## A d d e n d u m

Iowa Department of Transportation  
Office of Contracts

Date of Letting: November 15, 2016  
Date of Addendum: November 10, 2016

B.O.	Proposal ID	Proposal Work Type	County	Project Number	Addendum
104	78-0801-392	PCC PAVEMENT - GRADE & REPLACE	POTTAWATTAMIE	IM-029-3(82)52--13-78 IM-029-3(83)52--13-78 IM-NHS-080-1(392)0--03-78 IM-NHS-080-1(393)0--03-78 IM-NHS-080-1(394)0--03-78 IM-NHS-080-1(396)0--03-78	15NOV104A02

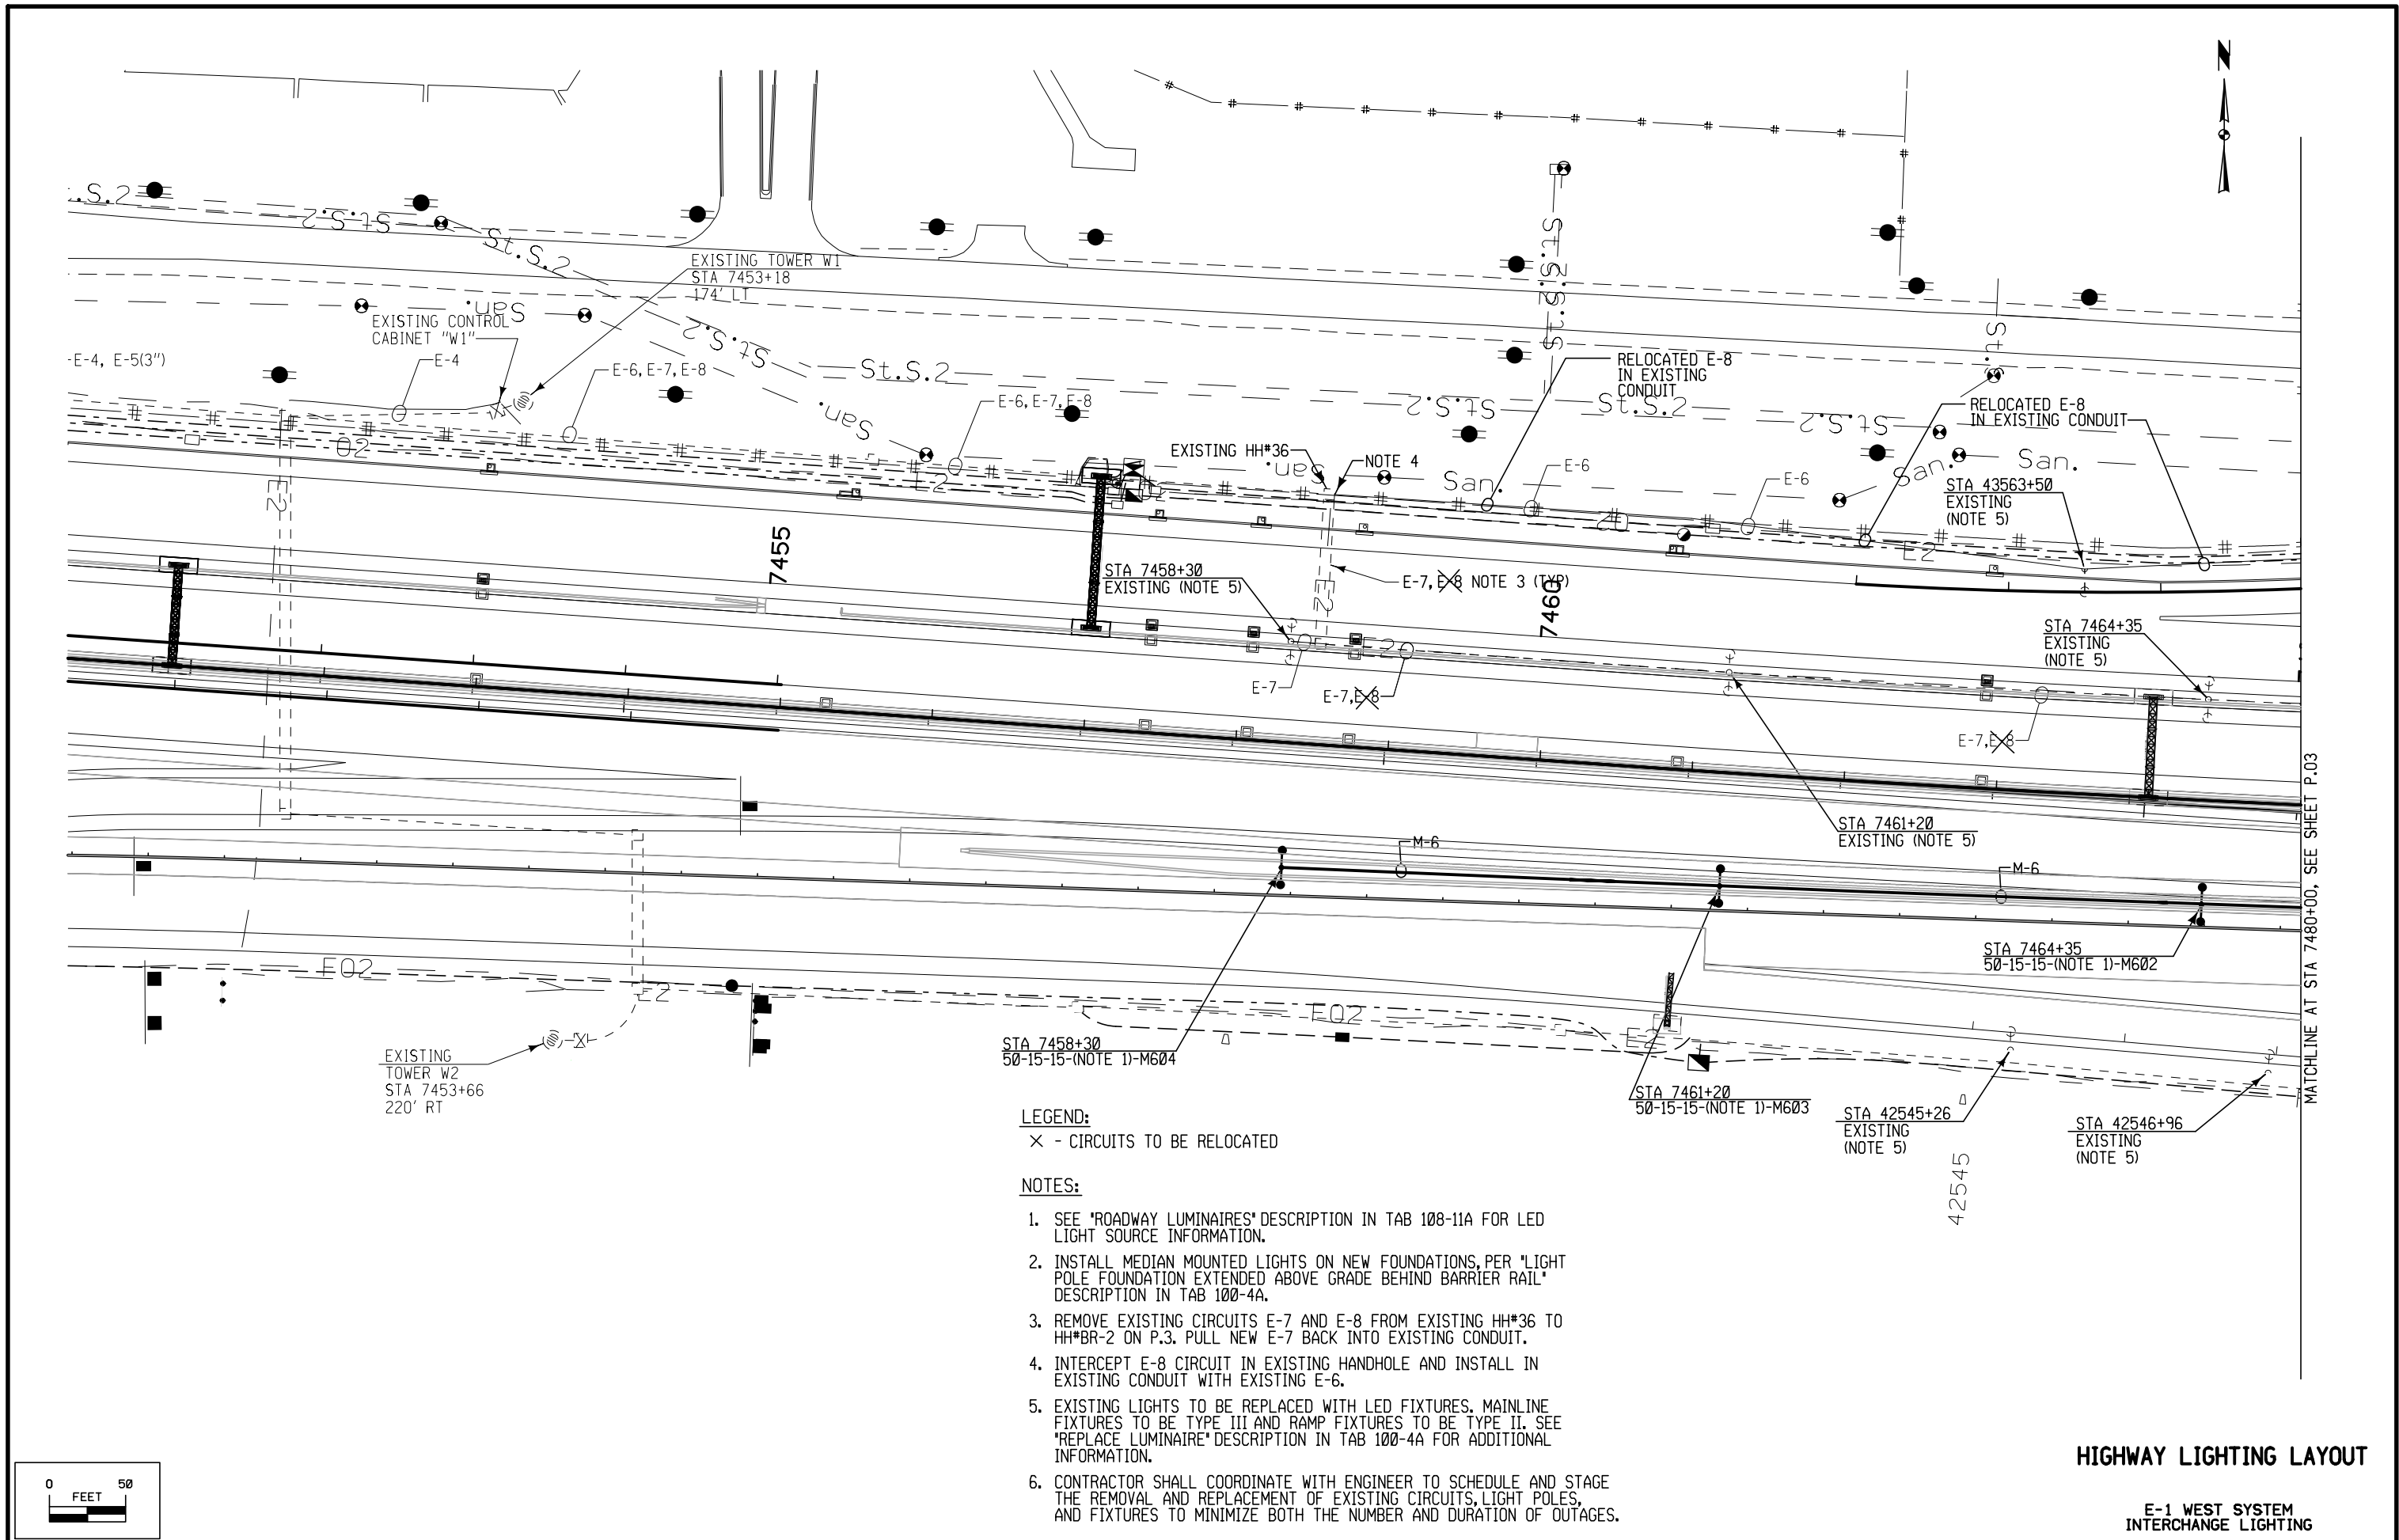
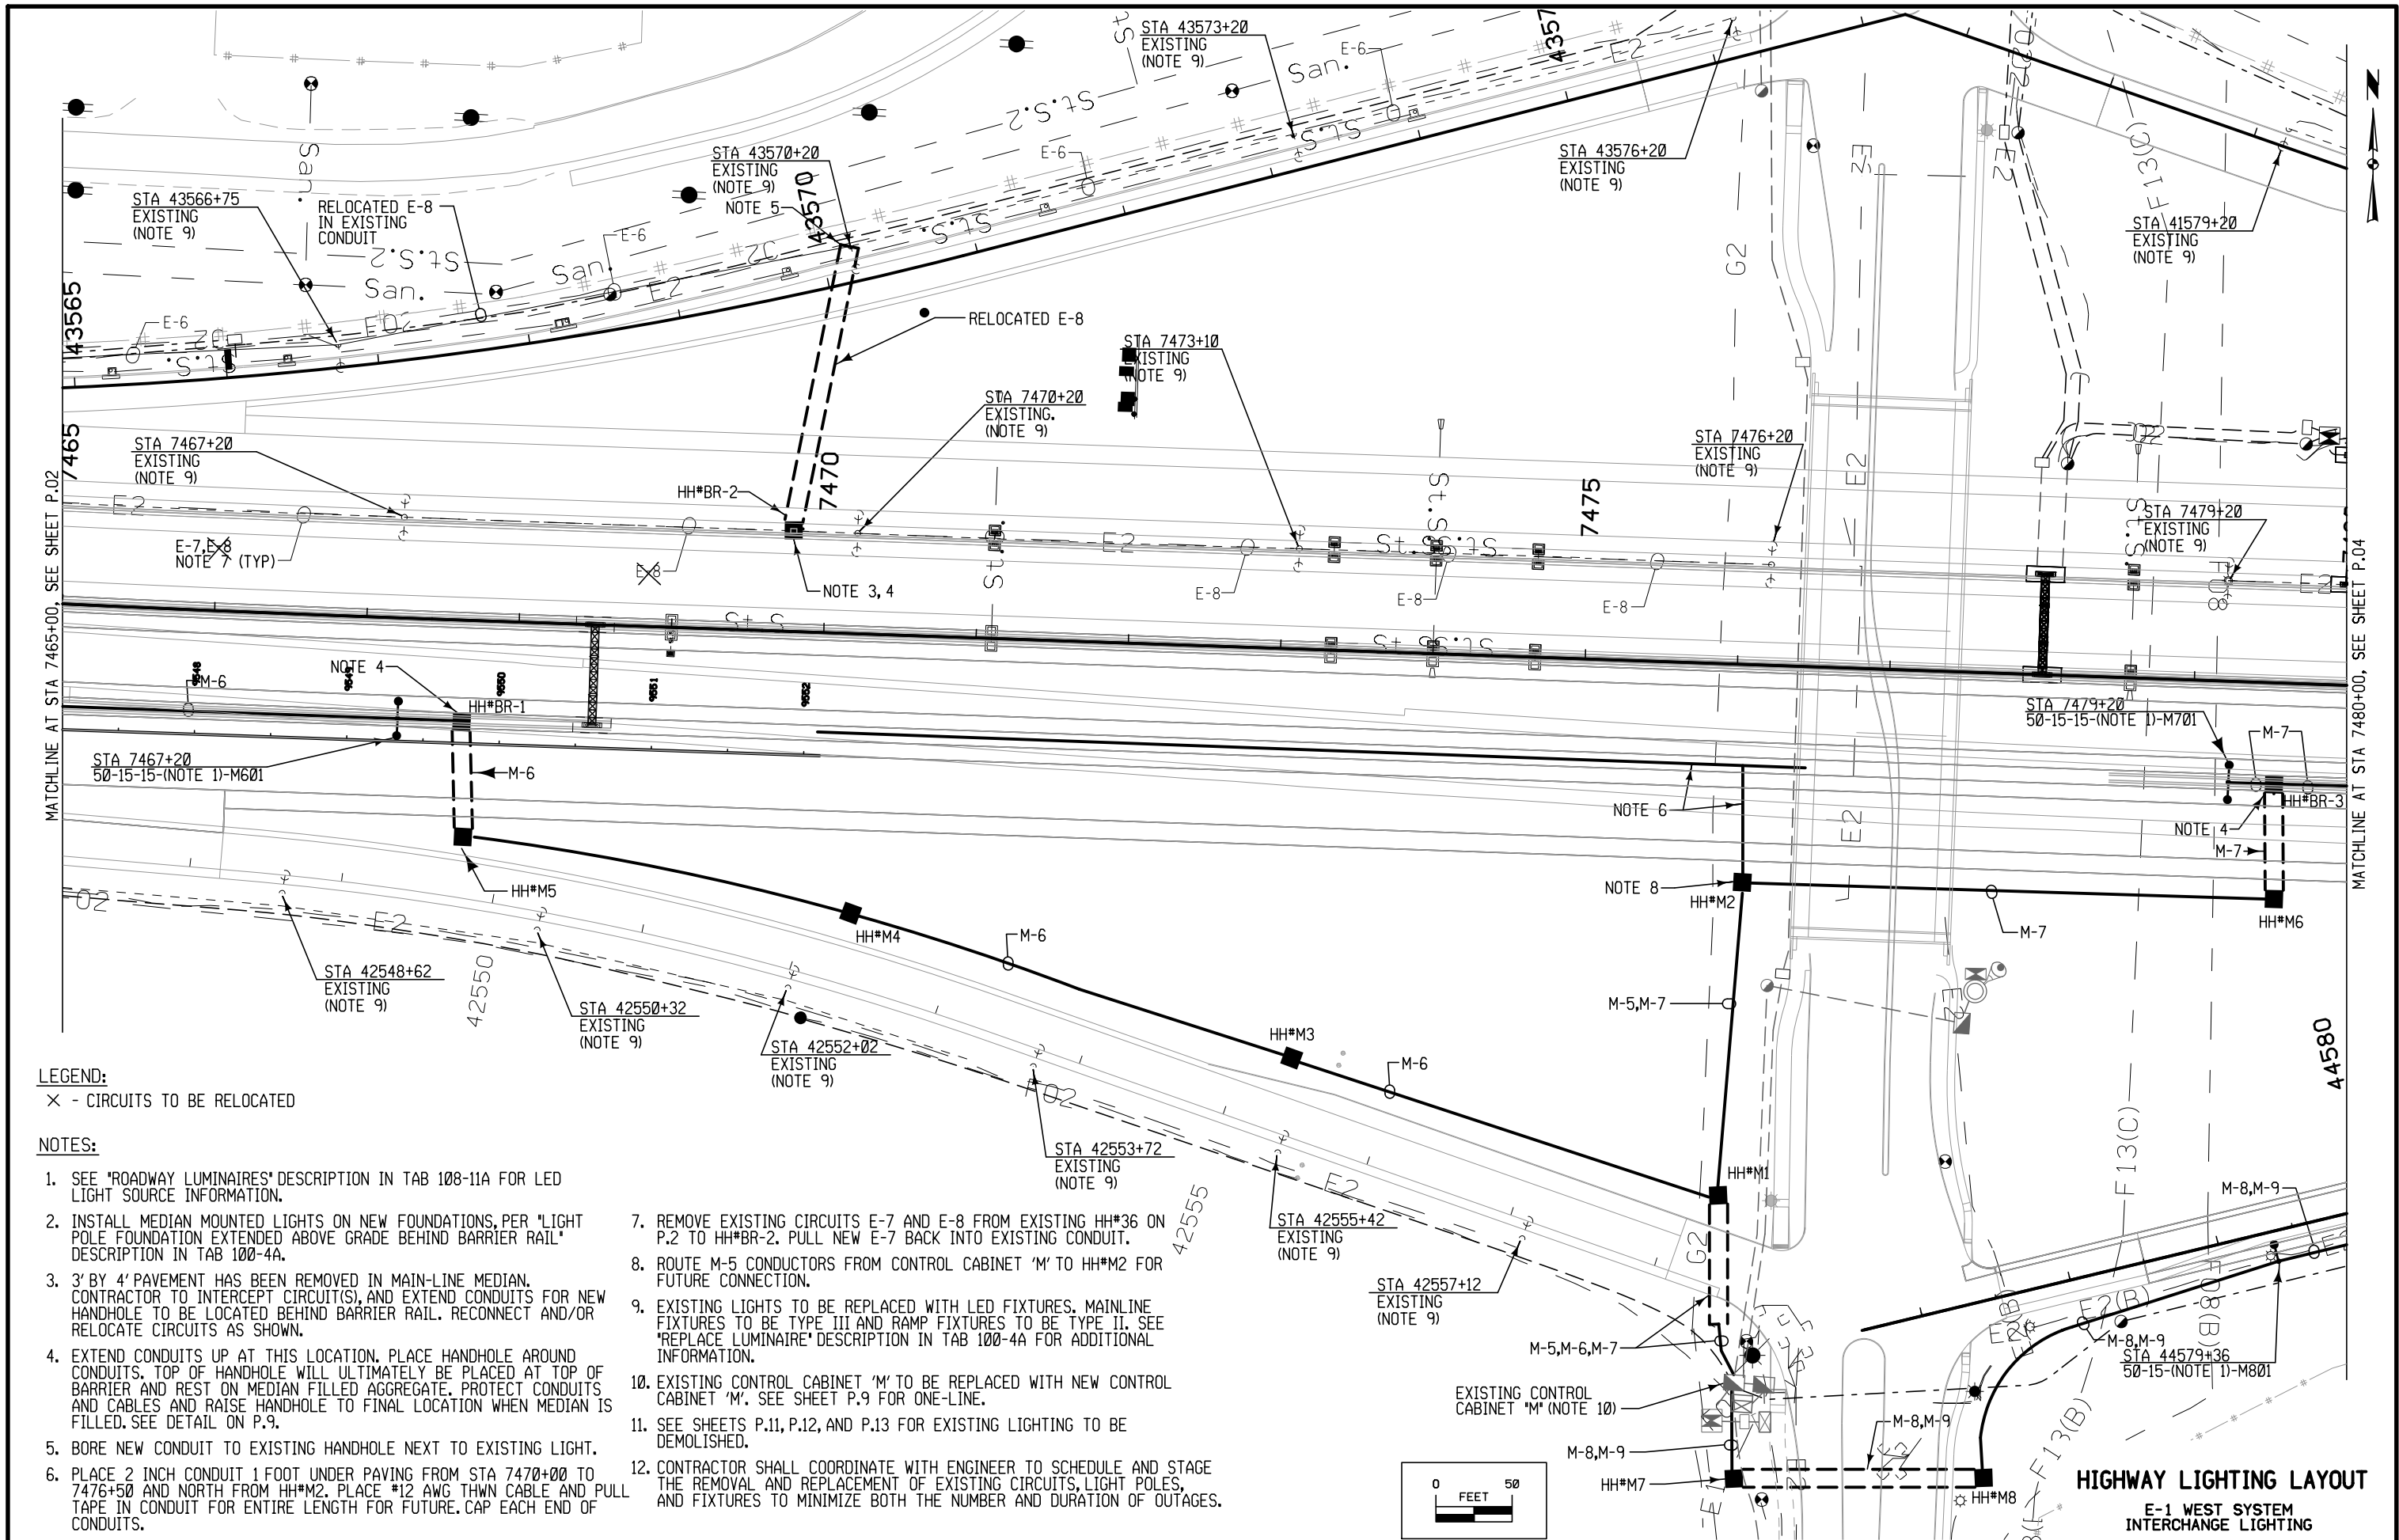
Replace plan sheets C.1, C.2, P.1, P.2, P.3, P.4, P.5 with attached for project.
